## Fuel leakage from cover to fuel filter housing

### Background

480 129

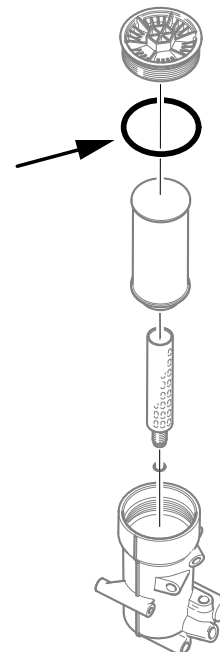
#### 1. PDE engine:

The new PDE O-ring kit must be ordered together with the filter kit. During service, the O-rings from the filter kit must be discarded and the new O-ring 3 188 368 must be used instead.

480 130

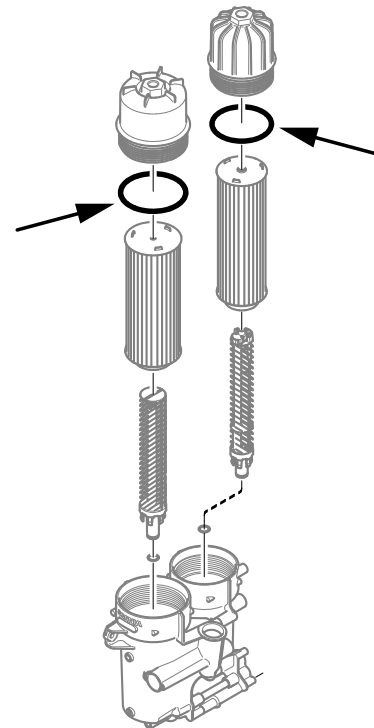
## 2. XPI engine:

The new XPI O-ring kit should be ordered together with the filter kit. During service, the O-rings from the filter kit must be discarded and the new O-ring kit 3 191 739 must be used instead.
